**From:** [Hendricks, Kyle](#)  
**To:** [cloverplanning@protonmail.com](mailto:cloverplanning@protonmail.com)  
**Cc:** [Stevens, Mike](#)  
**Subject:** 1011 Queensgate Landscaping  
**Date:** Wednesday, March 5, 2025 10:23:00 AM  
**Attachments:** [image001.png](#)

**From:** [Clover Planning](#)  
**To:** [Hendricks, Kyle](#)  
**Cc:** [Stevens, Mike](#)  
**Subject:** SUP PLN-T2-2025-00011  
**Date:** Thursday, March 6, 2025 4:03:30 PM  
**Attachments:** [Turbo Coffee Shop Landscape Plan-L1.pdf](#)

PLN-T2-2025-00011 & PLN-T1-2025-00176 1011 Queensgate Dr

**Proposal:** Clover Planning and Zoning LLC on behalf of Heavy 2 LLC has filed a special use permit application to allow the development of a drive through coffee stand. The coffee stand is proposed to be approximately 800 square feet in size with a small patio area and will be located adjacent to an existing gas station and car wash facility. The parcel is approximately 1.47 acres in size.

Landscape Plan

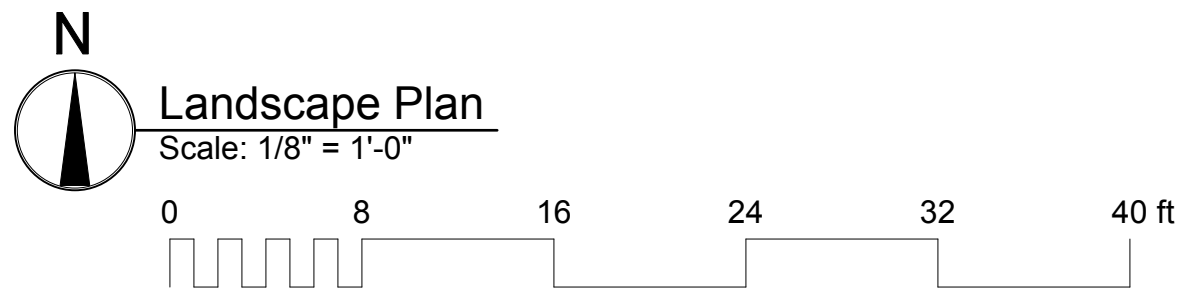
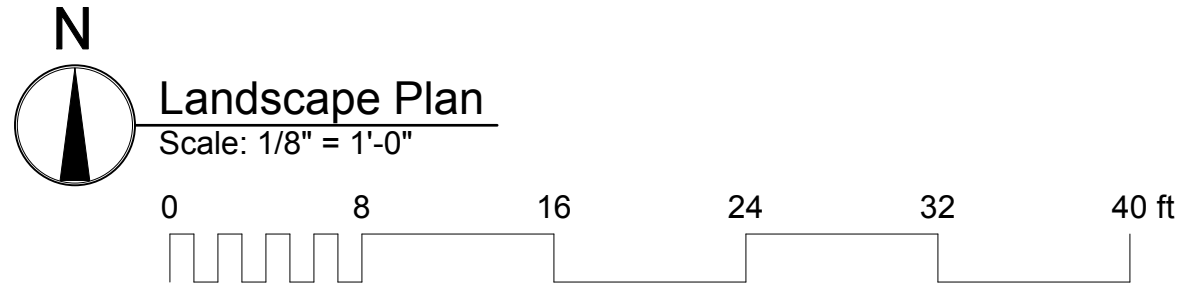
To help ameliorate Planning's concerns expressed during Monday's hearing, I want to enter this draft off-site landscape improvement plan providing pedestrian access from the public path to the raised & marked crossing, with signage, to the patio. I'll get this over to the Parks Department and copy Joe.

On behalf of the owner of 999 Queensgate Drive, I want to initiate the process of permitting the landscaping improvements shown in the attachment, on City-owned parcel #122983000010002. Joe is copied here because I understand the owner (Raj) discussed this plan with him and received optimistic feedback. I imagine there will be some type of perpetual maintenance agreement.

PRELIMINARY  
SITE PLAN

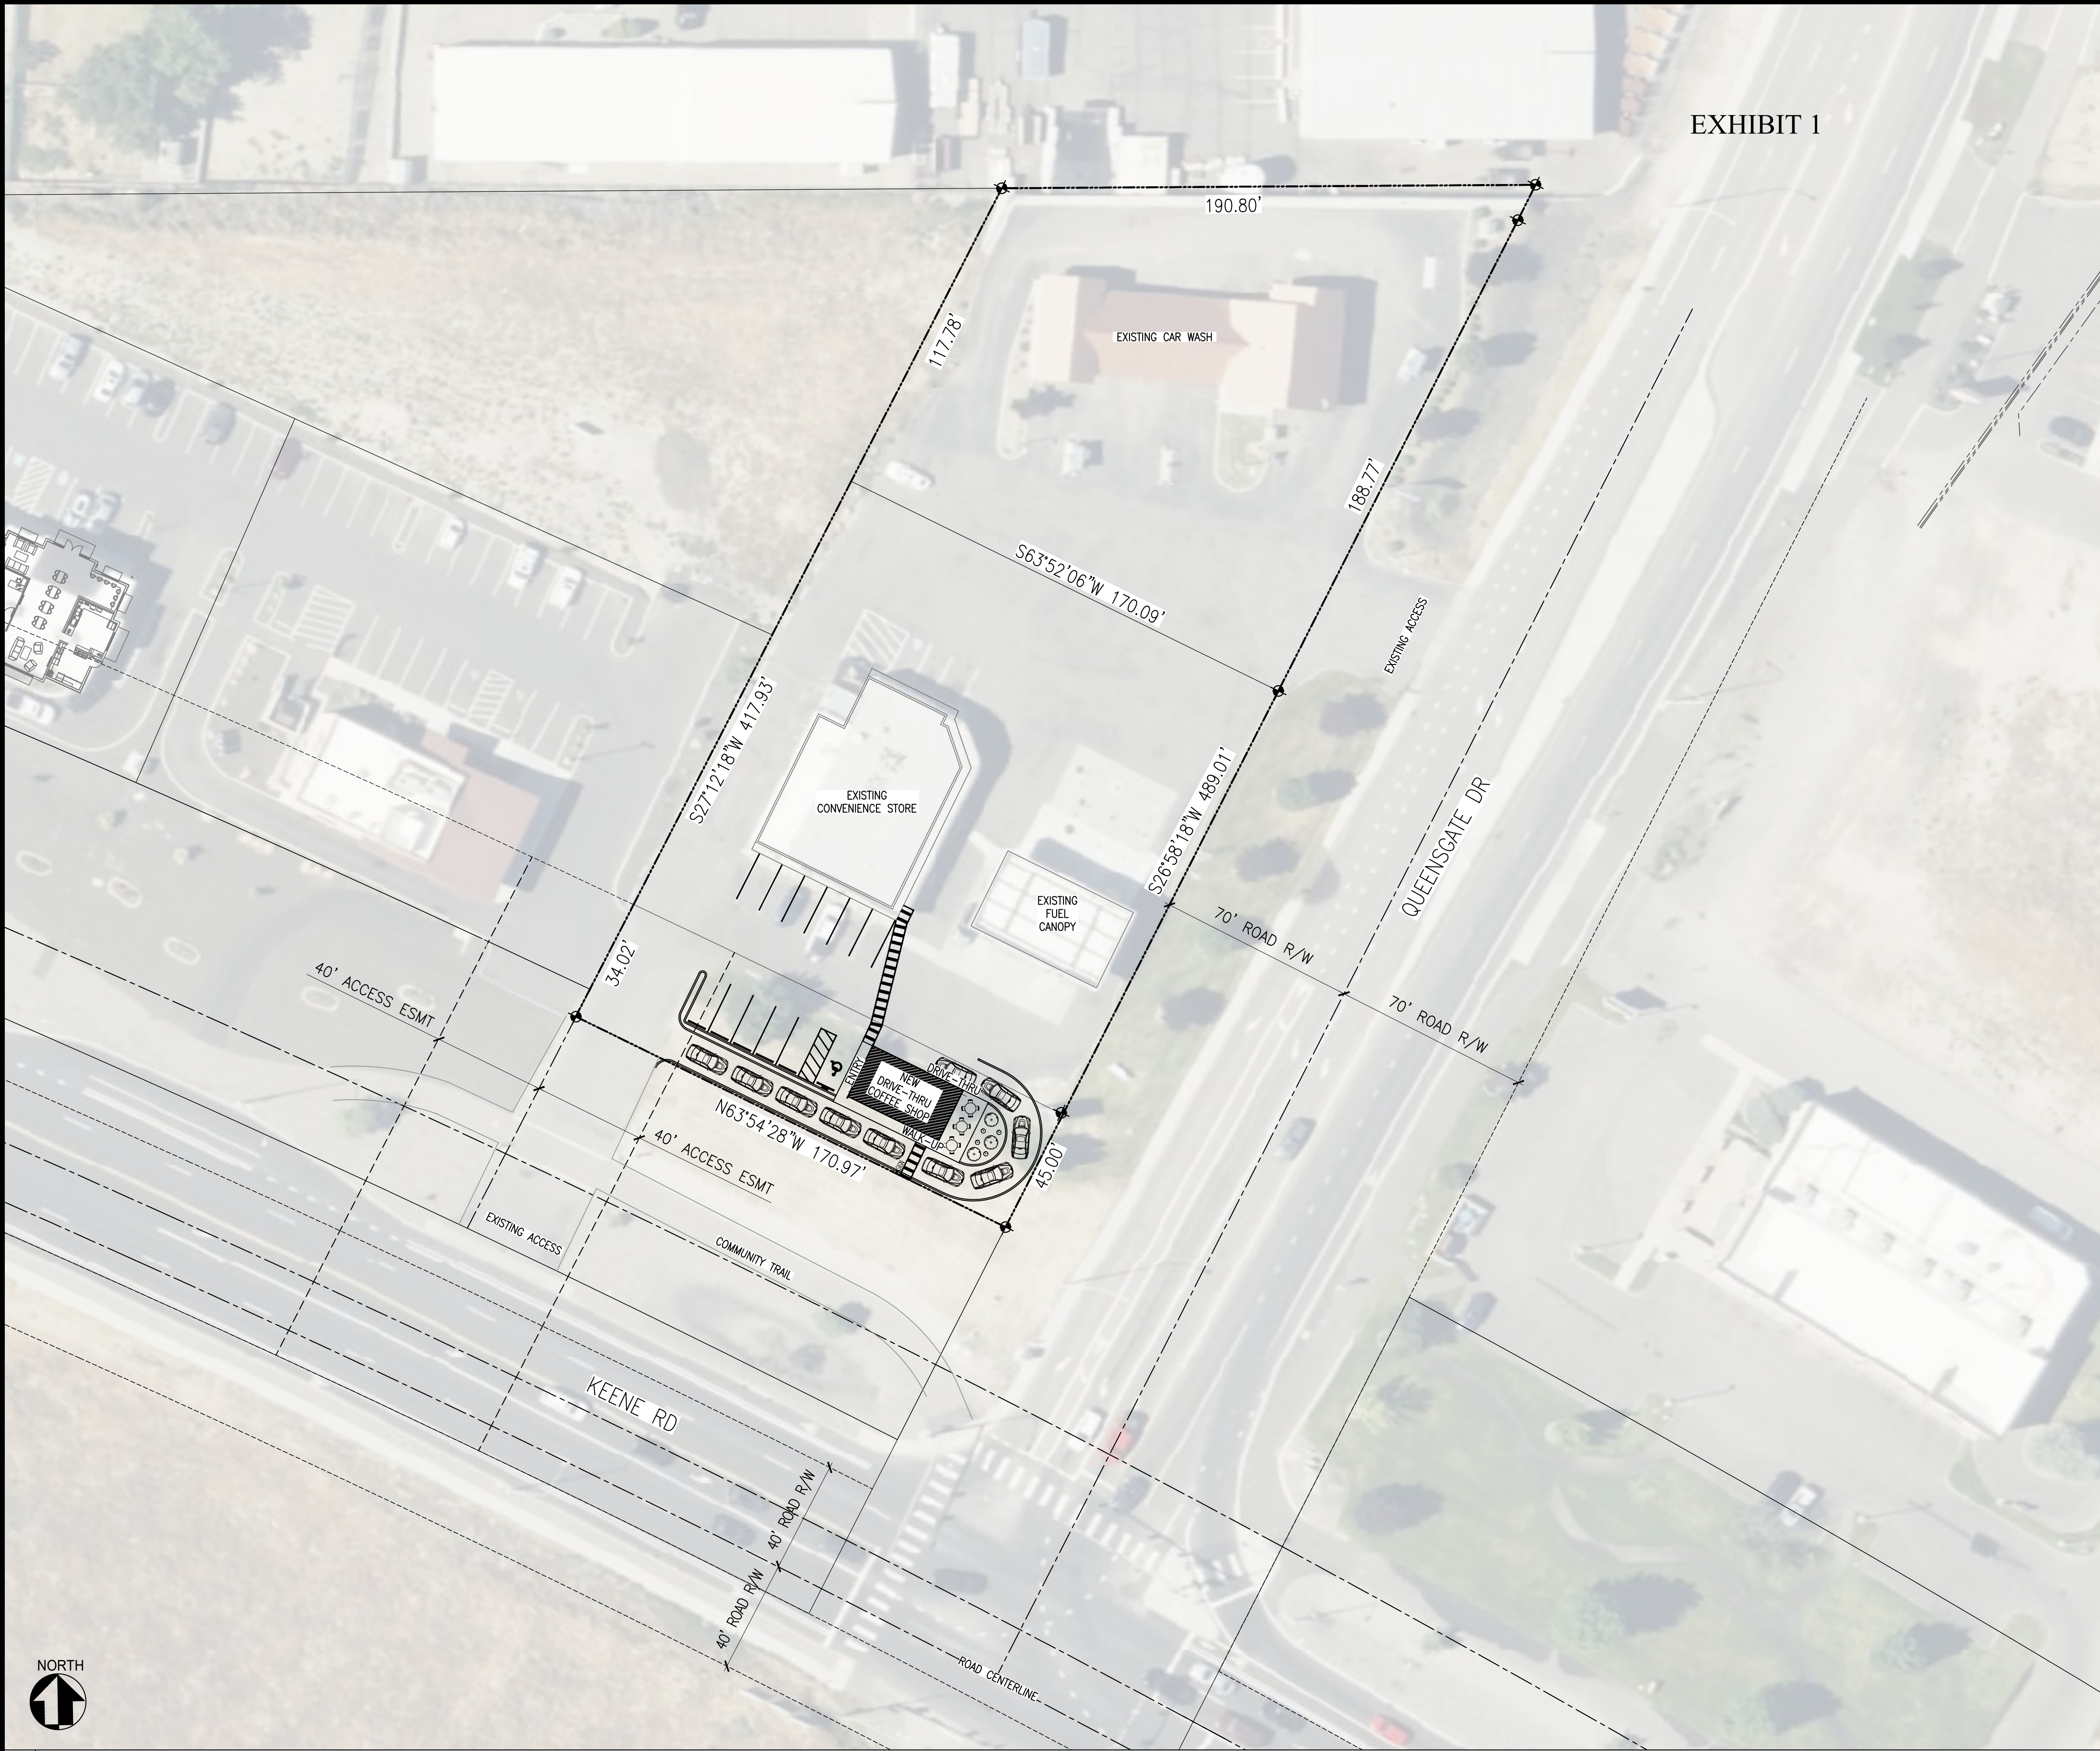
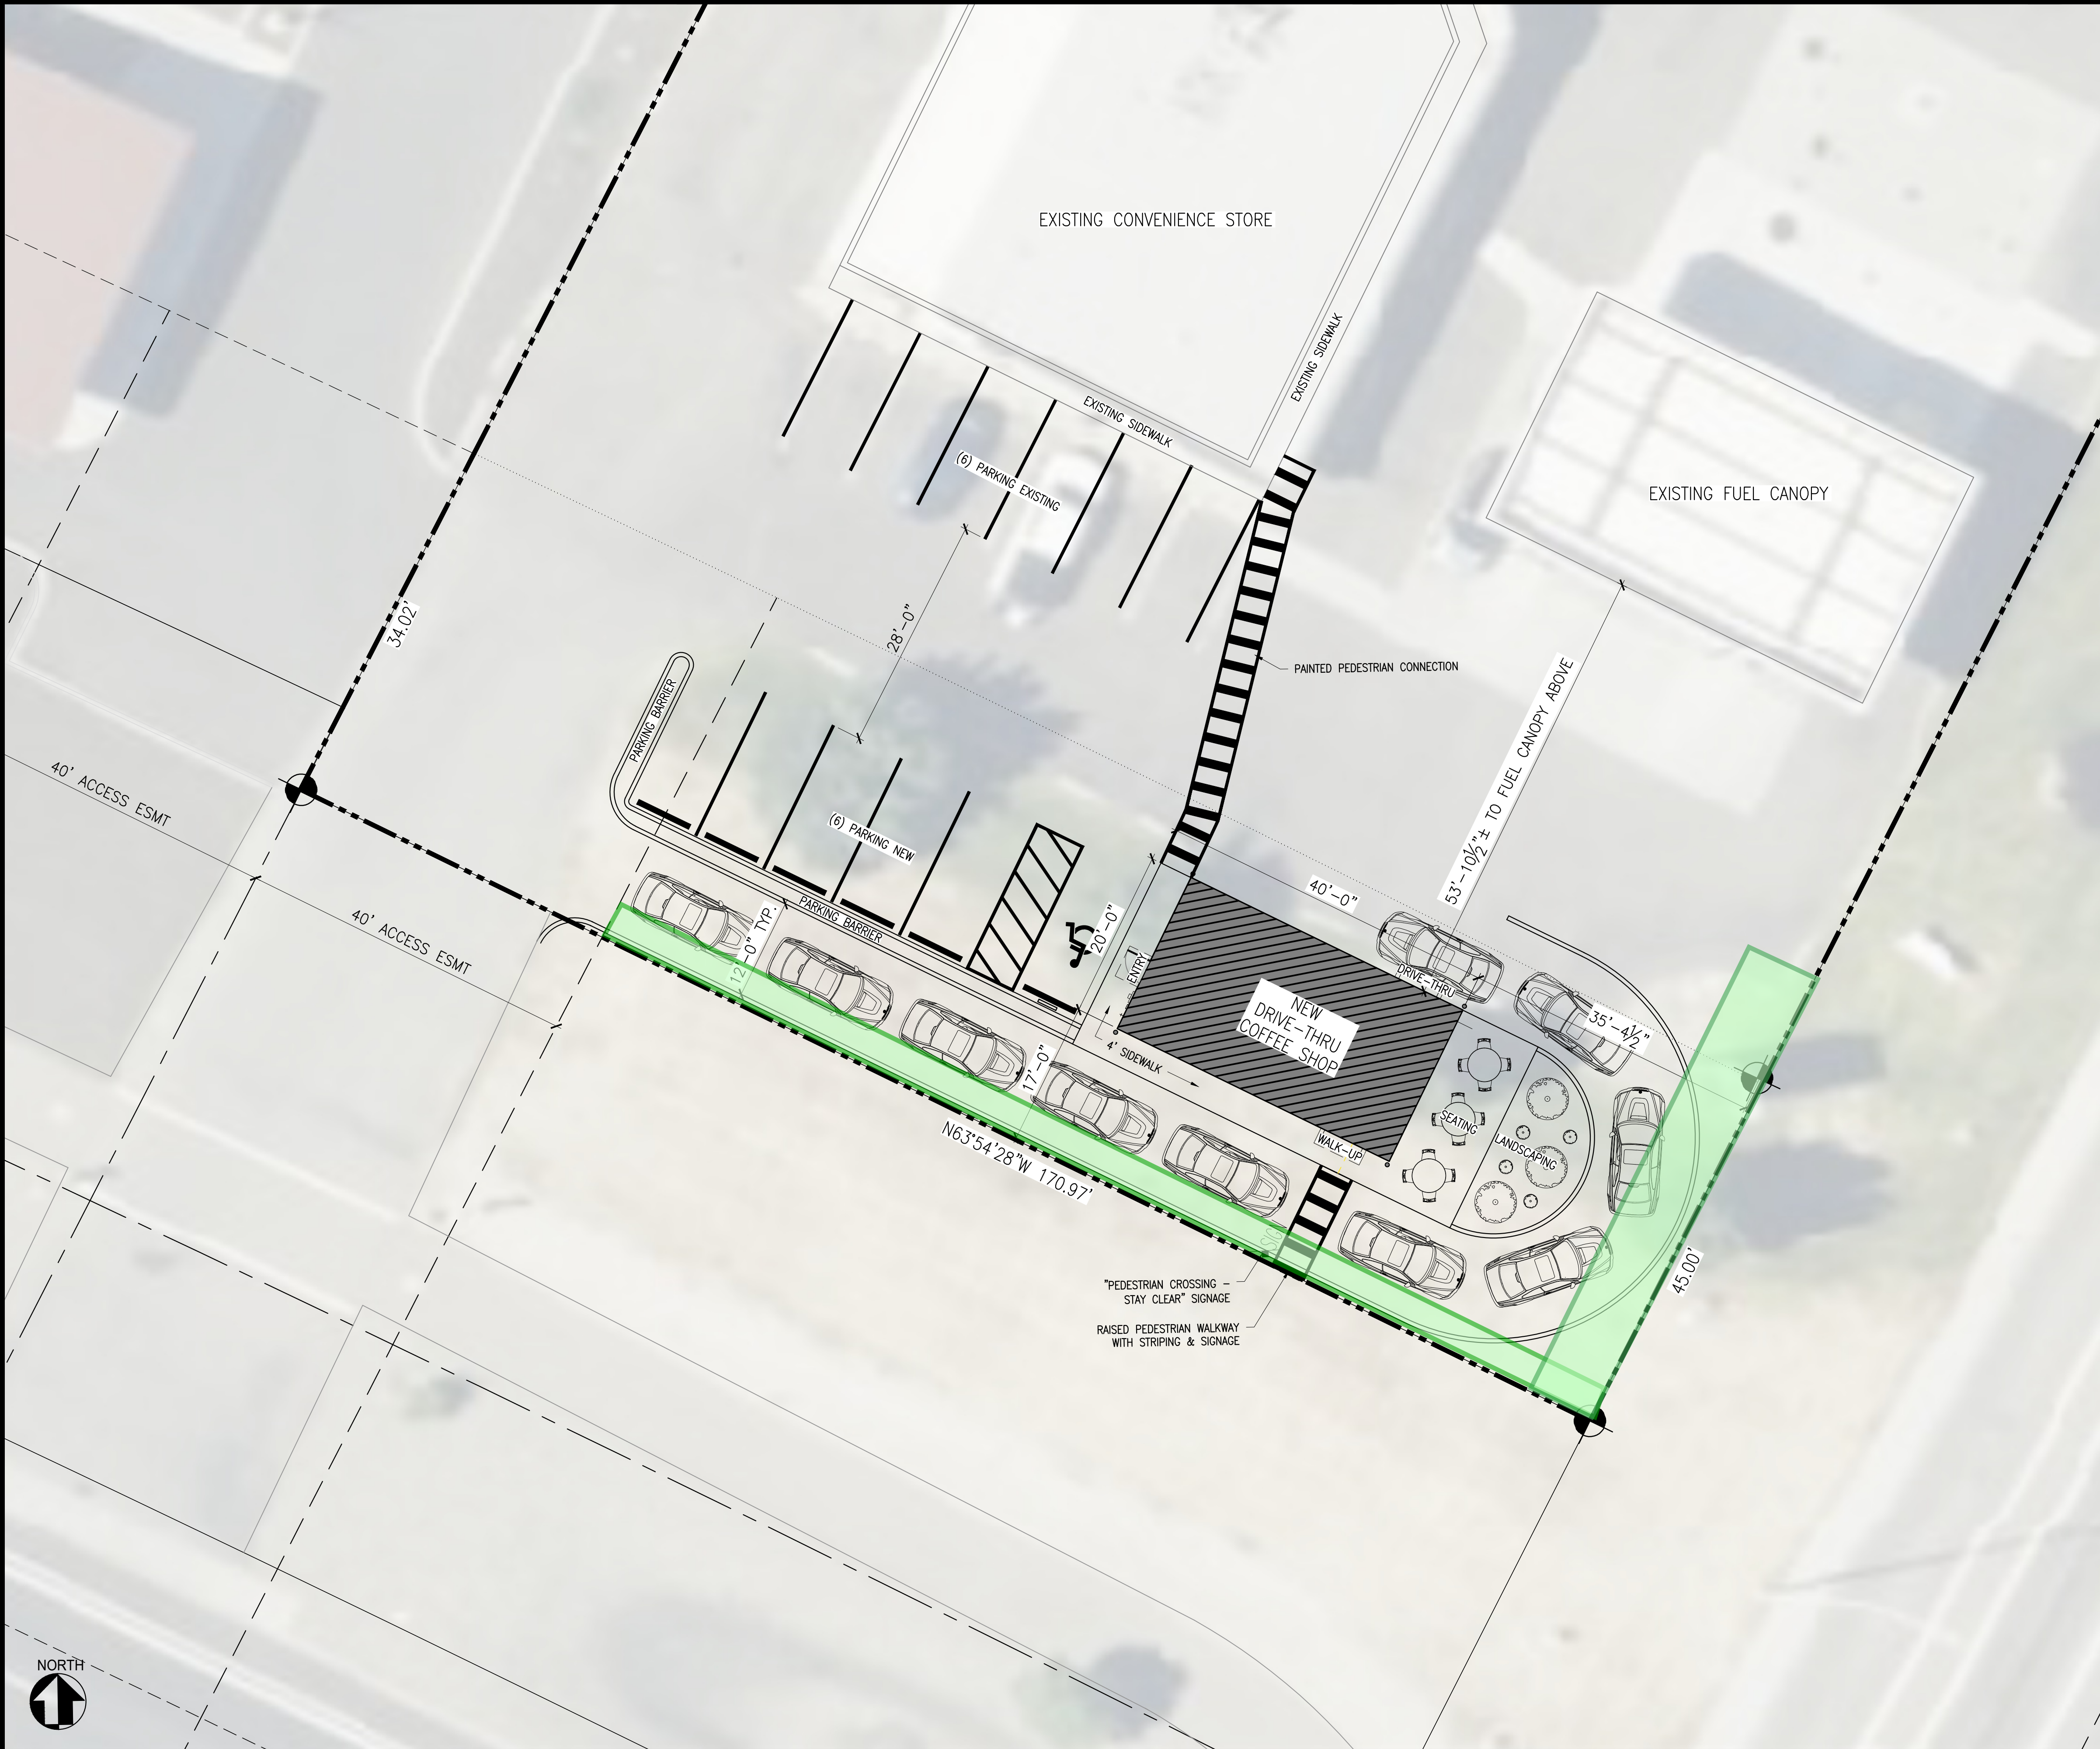
The current site plan indicates no on site perimeter landscaping along either of the adjacent property boundaries. The drive through lane appears to be right up against the property boundaries. The Keene Trail side is an abutting property, therefore it is required to have a minimum 5' wide landscape strip. As this is public park space and not an additional parking facility, it would be in the public interest to provide some screening between the trail and an auto oriented use like the drive through coffee stand. The subject property is also immediately adjacent to the City Right of Way of Queensgate Drive. Public Works comments mention that it is likely that Queensgate will be widened, or otherwise altered in some manner that Planning cannot account for, it is possible for any road expansion to utilize all Right of Way space, therefore a 10' wide landscaping strip would be required on site in accordance with condition "D" above,. This is consistent with the Drive through Coffee Stand at 590 Gage (PLN-T2-2024-00003) which has a 10' Landscaping strip along both City Right of Way (Leslie and Gage). The adjustment of landscaping standards (RMC 23.54.150) process is available, also stated in condition 6.
